**From:** John M. Bowman <JBowman@elkinskalt.com>  
**Sent time:** 05/29/2020 07:48:17 PM  
**To:** mindy.nguyen@lacity.org  
**Subject:** Comments on DEIR for Hollywood Center (Case No. ENV-2018-2116-EIR)  
**Attachments:** DEIR Comment Letter.pdf

Re: Case No. ENV-2018-2116-EIR  
Project name: Hollywood Center Project  
Comments on Draft Environmental Impact Report

**Figure 1 – Veneklasen Receptor Location Map**

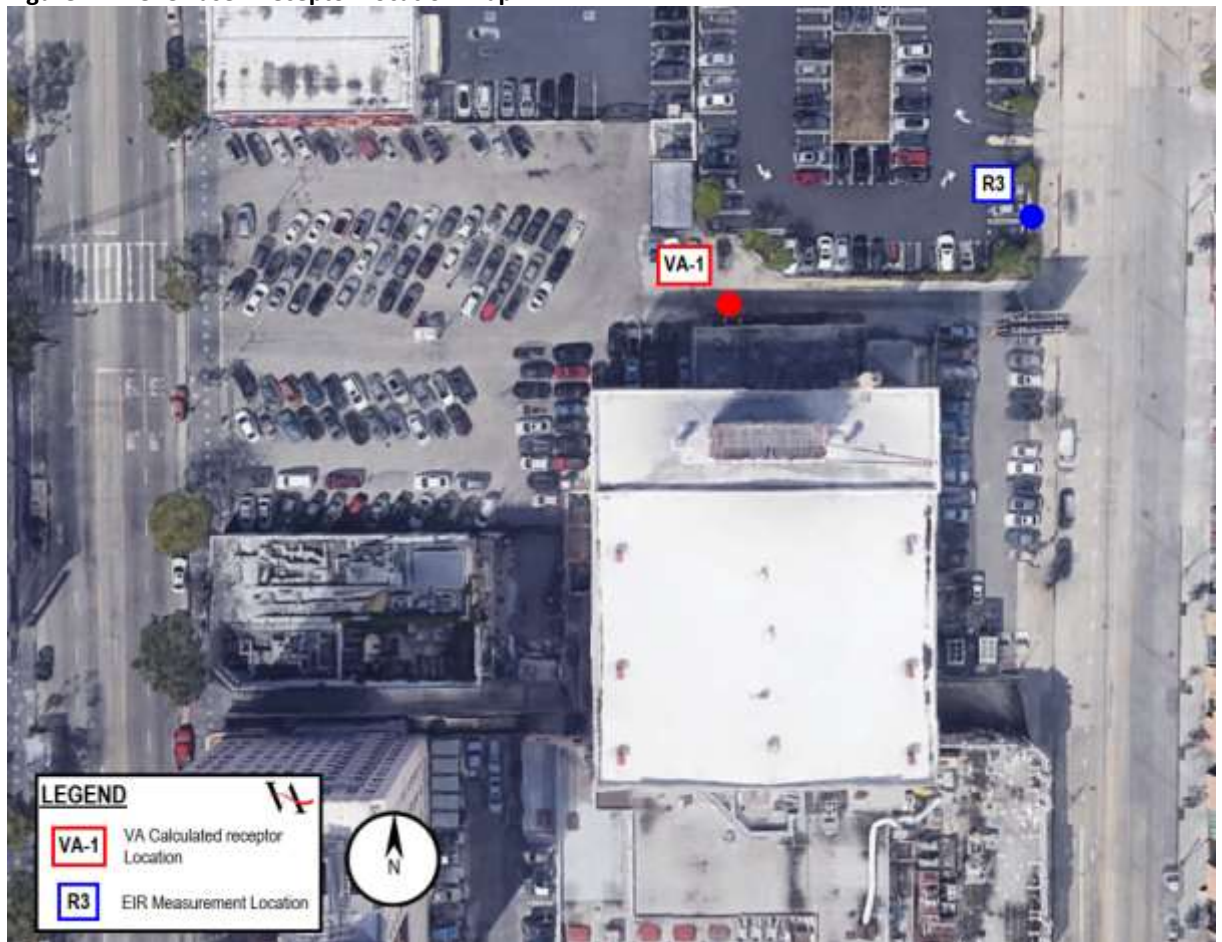
Draft EIR Page IV.I-21, Table IV.I-5: The measured noise level at measurement position R3 is not representative of the noise levels at the back of the Pantages Theater. The measured ambient level for the Pantages Theater indicated in Table 1, Appendix K-2 states that the measured level is 60.1 dBA at R3 along Argyle Avenue. This is not representative of the sound levels in the access alley behind the theater where there is some exposure to Vine Street, but also significant acoustical shielding because of building geometry which does not appear to be accounted for. Veneklasen performed a distance and angle attenuation analysis at Veneklasen receptor location VA-1 which is shown in **Figure 1**. Using the measured level at R3 along Argyle Avenue and the measured level at R2 on Vine Street, Veneklasen calculated the ambient noise level at VA-1 to be approximately 56 dBA, accounting for increased distance and reduced angle of exposure. As such, the significance thresholds identified in Table IV.1-19 and Table IV.1-10 for the Pantages Theater (receptor location no. 9) are significantly higher, which has the effect of understating the impact of construction noise on the Pantages Theater. Additional sound level measurements should be performed of suitable duration to determine the ambient levels in the alley behind the Pantages Theater. Veneklasen would suggest a minimum measurement duration of 72 hours during normal weather conditions.

Additionally, once the subject project is constructed, the alley behind the Pantages will be completely shielded from Vine Street, and the angle of exposure to traffic noise from Argyle Avenue will be further reduced, likely causing the noise levels to decrease further. Veneklasen estimates the post-construction ambient noise level in the alley behind the Pantages Theater to be approximately 47 dBA.

**Figure 2 – Background Music Distance Attenuation Locations**

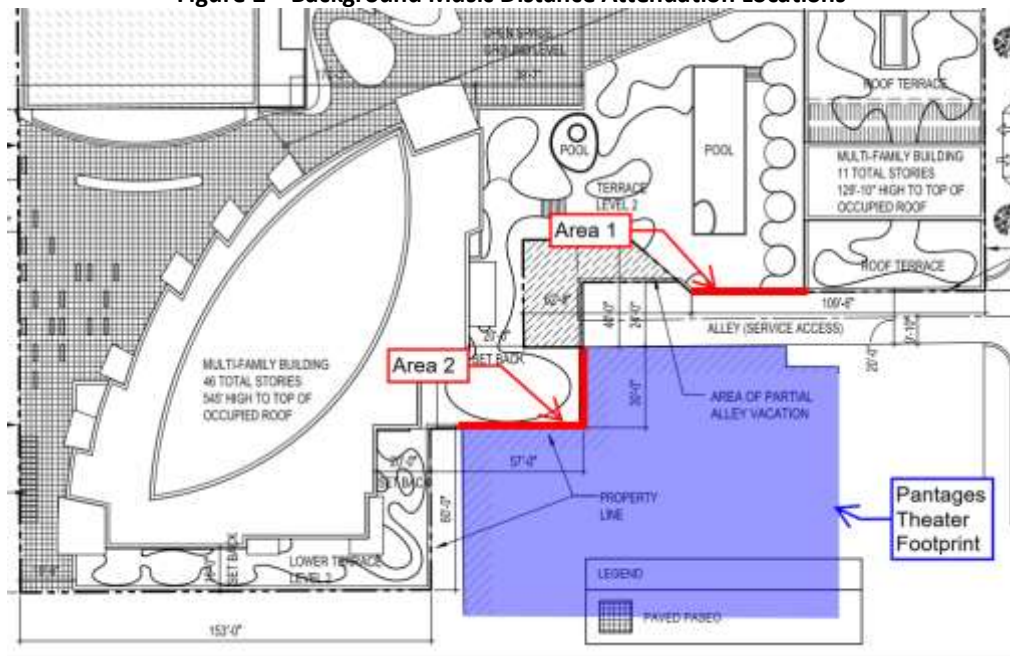
Draft EIR Table IV.I-12 and Page IV.I-51: On page IV.I-51 it is stated that the “sound level of the music speakers is conservatively assumed to be 75 dBA at 25 feet, which is more than 5 dBA higher than the ambient noise levels in the vicinity of the Amenity Deck (Level 2), East Site, which ranges from approximately 60.1 to 68.3.” The predicted noise level pre-construction is 56 dBA and as stated in **Item I** above, Veneklasen predicts the post-construction noise level from Argyle Avenue to be about 47 dBA. Both predicted pre-construction and post-construction noise levels are significantly lower than the assumed 60.1 stated in the Draft EIR indicating that additional review and analysis should be performed. The areas from which Veneklasen performed a distance loss calculation between the Amenity Deck (Level 2), East Site and the Pantages Theater are shown in **Figure 2** below:

The distance from Area 1 to the Pantages Theater is 20 feet and the Distance from Area 2 to the Pantages Theater is 0 feet. For the purpose of an accurate analysis, Veneklasen has assumed a minimum distance of 5 feet from the nearest music speaker for Area 2. The results of these calculations are shown in **Table 3** below:

Figure II-19 indicates that under the East Site Hotel Option, there will be a swimming pool located in Area 2 is as shown in **Figure 2** above. Using the same calculation methods to determine the sound levels from speech at the Pantages from this area, the noise level will be 80 dBA at the Pantages. This would be a significant on-going impact and this area cannot be occupied by a pool, as any operation will significantly exceed both proposed interior noise guidelines and could negatively impact rehearsals and other theater operations.

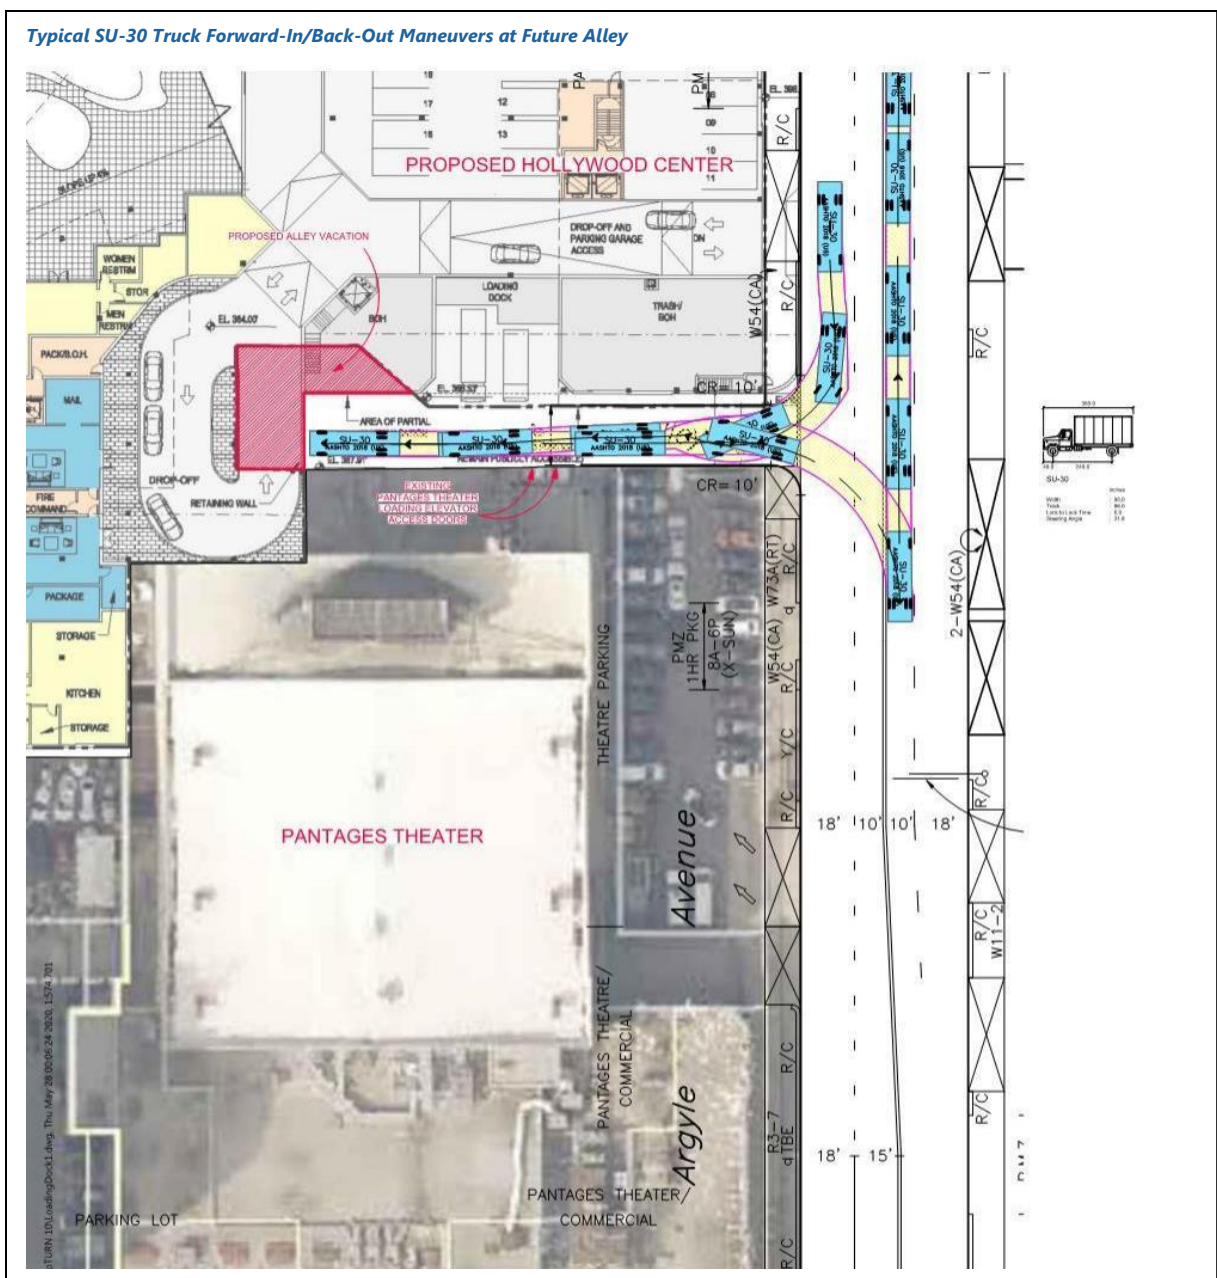
Figure 2D, which indicates that Project drop-off/pick-up area will occupy the vacated portion of the alley, is consistent with Figure II-14 in the Description of Project section of the DEIR, which indicates that this vacated portion of the alley is to have walls constructed separating it from the remaining alley, thus creating a dead-end condition for the shared alley with no turnaround space for service trucks. The alley turnaround area is currently used for daily delivery trips by the Pantages Theatre, trash pickups, and other services, and needs to remain usable without impedance. Under the existing conditions, standard single-unit trucks (SU-30) can utilize the turnaround area to depart without having to back out of the alley:

Under the proposed conditions, a typical SU-30 truck will no longer be able to turn around in this dead-end alley, and must back out of the alley driveway in order to depart, thereby adding even more truck movements on Argyle Avenue. Below is a typical scenario in which a SU-30 truck would have to maneuver in order to arrive and depart the alley:

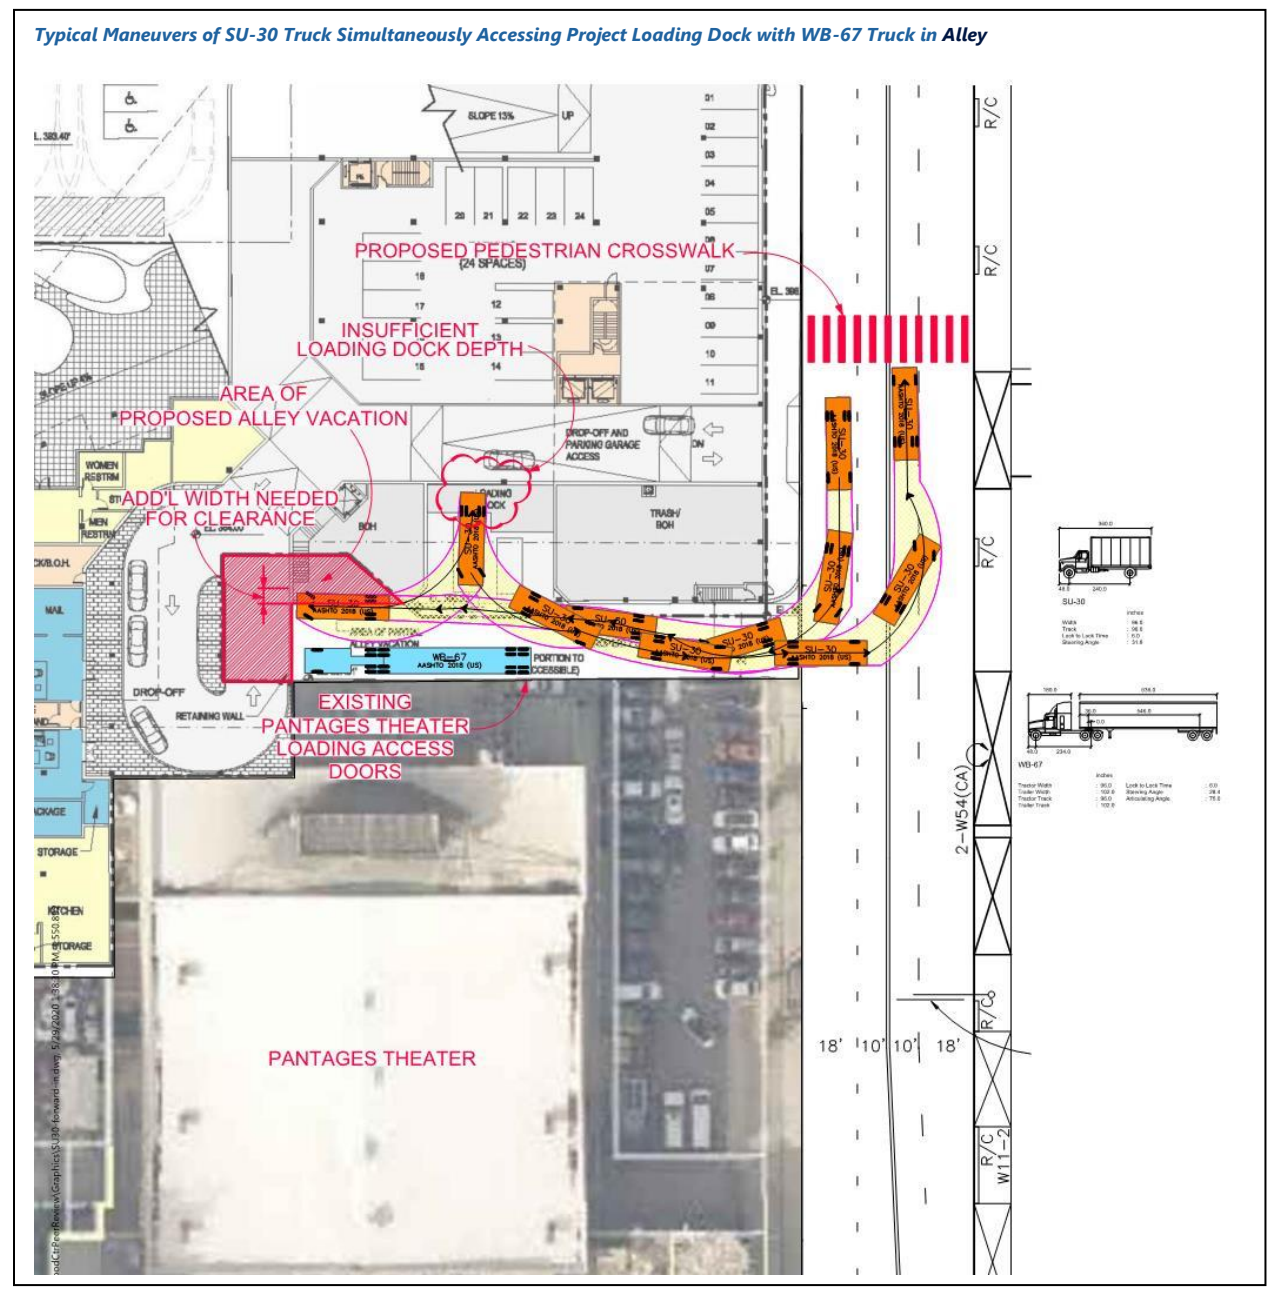
The safety concerns of requiring daily delivery trucks for the Pantages and other south side users of the alley to now back out rather than turn around needs to be analyzed and fully addressed. The analysis needs to consider having the trucks back up past the Pantages elevator and other alley activities, across the

Further, when trucks serving the Pantages Theatre occupies a portion of the currently proposed alley for loading and unloading, the Project loading dock is rendered inaccessible, as it does not have sufficient depth to accommodate the simultaneous uses that can occur within a shared use alley such as this one. An example of such a condition is shown below:

As shown above, in order for a SU-30 truck to access the project loading dock while a semi truck is positioned in the alley, additional width is needed in order for the su-30 truck to bypass the WB-67 semi

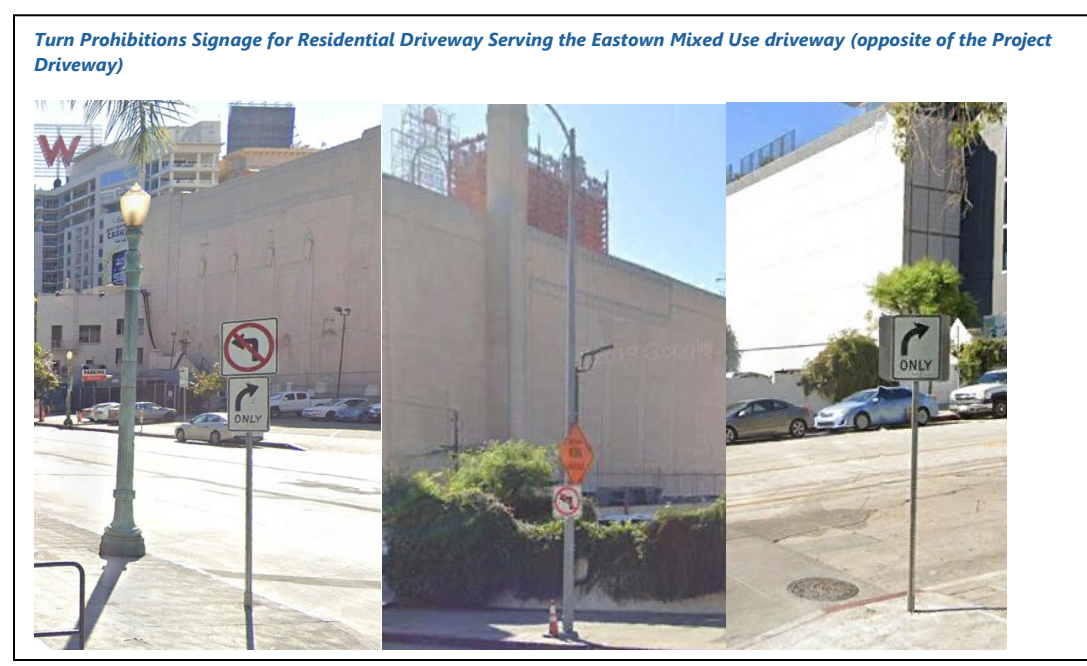
The mid-block pedestrian crossing proposed across Argyle Avenue is cited throughout the TA as a Project feature. However, the pedestrian crossing on Argyle is not characterized or analyzed as it is proposed – a crossing that is part of a four legged intersection, with two legs being private dust-pan style driveways, and with the Project driveway “daylighting” from a subterranean parking garage, which is essentially the terminus of a speed ramp. Based on the City of Los Angeles standards, dustpan-style driveways connecting the street do not receive a full traffic signal (red-yellow-green indicators). Instead, the City of Los Angeles Department of Transportation generally limit these types of intersections to receiving at most a “red flashing” indicators for the driveways, or install only devices for the pedestrian crosswalk. Unless both the Project driveway and the driveway serving the Eastown mixed-use development are flanked by step-down curb and radius designs, the signalization for this location would not typically be granted a full traffic signal operation. A pedestrian crossing immediately adjacent to and part of the same intersection containing a speed ramp from a subterranean parking structure presents limitations to visibility of a pedestrian crosswalk that is directly next to this speed ramp. The safety implications of the pedestrian crossing next to a subterranean ramp, rather than at a mid-block location, are not discussed nor analyzed. Further, the dust pan driveway design increases potential safety conflicts with pedestrians. Additionally, the dustpan configuration and sight distance concerns are further exacerbated by Argyle Avenue having an approximately 7% uphill slope north of the Project driveway. A more detailed safety analysis of this entire concept should be further studied.

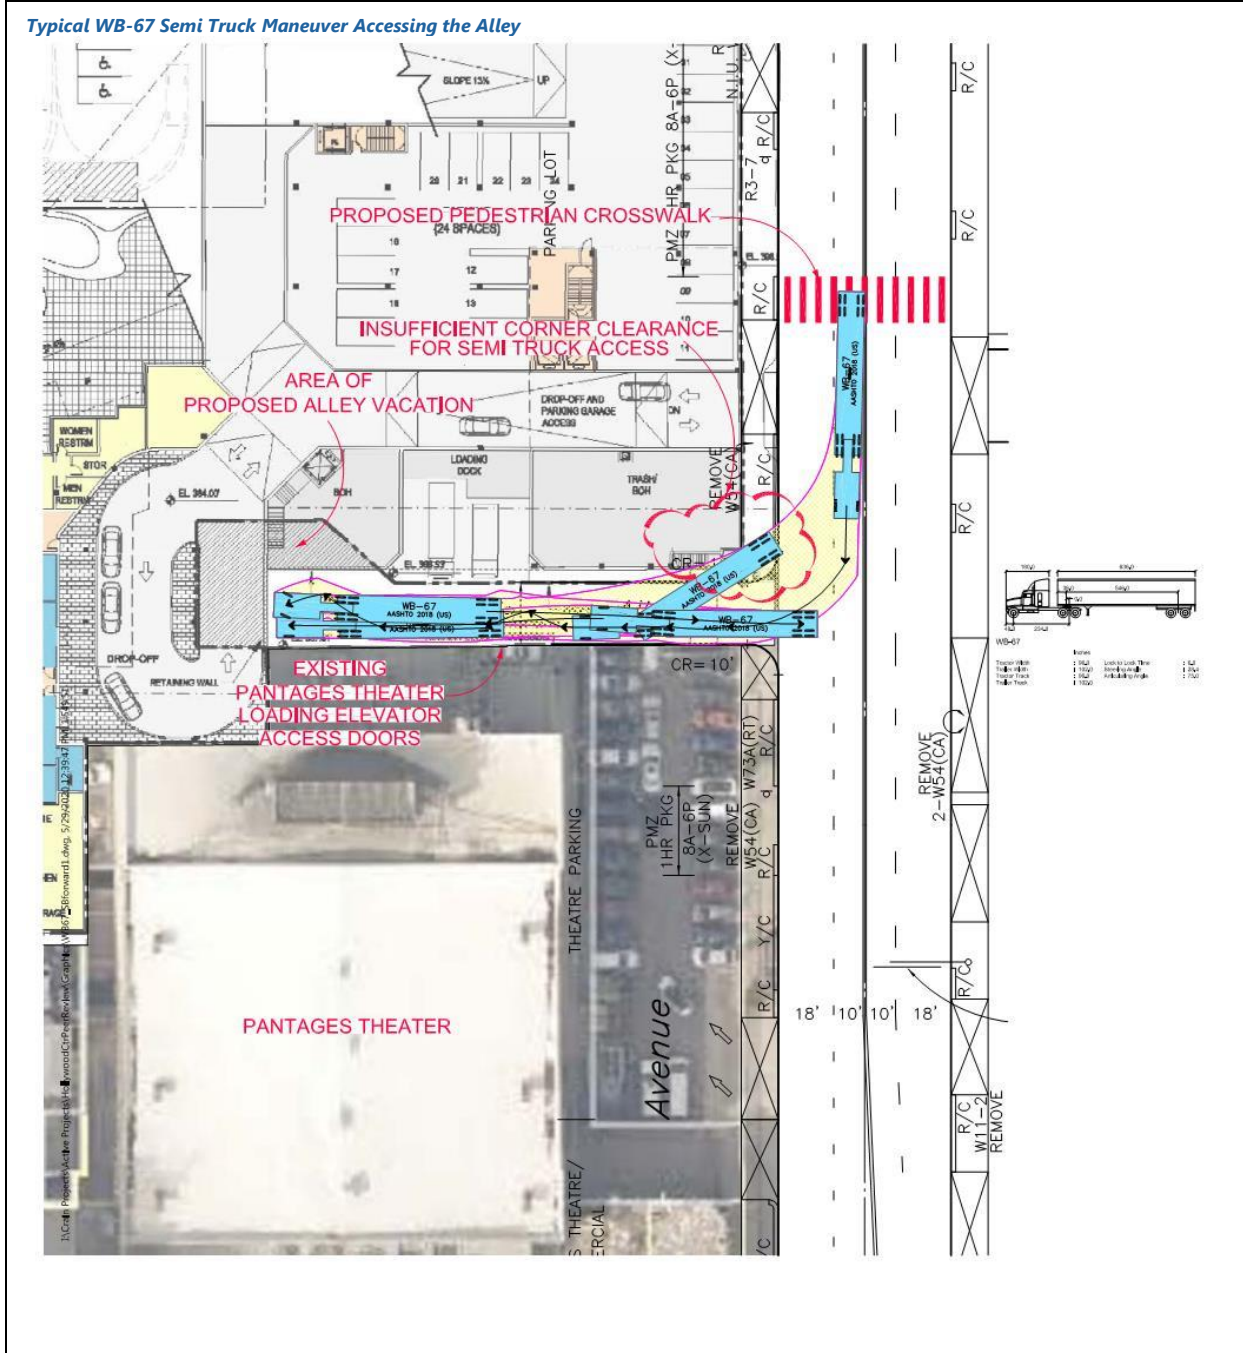
These traffic signage were installed as part of the Easttown development at the request of LADOT. Typically, LADOT imposes left turn prohibitions to private driveways as a tool to reduce the amount of additional traffic added to an already congested roadway, or as a means to reduce the probability of potential traffic safety conflicts in that specific location. Vehicles exiting the Easttown driveway making left turns into a gridlocked traffic condition may block northbound traffic from flowing through while waiting for a gap in the southbound traffic. While common wisdom may deduce that having a signalized intersection that serves both the Project and the Easttown driveways would alleviate these concerns, the introduction of a new traffic signal will cause further delays on Argyle Avenue, as it will increase wait time. A comprehensive queuing and signal timing synchronization study, along with safety, and neighborhood traffic management analysis of Argyle Avenue and the Project driveway should be conducted, as queuing will be an added issue for a full signal with phases activated by automobiles exiting either driveway.

Based on those considerations, the following statement on Page 123 is not correct:
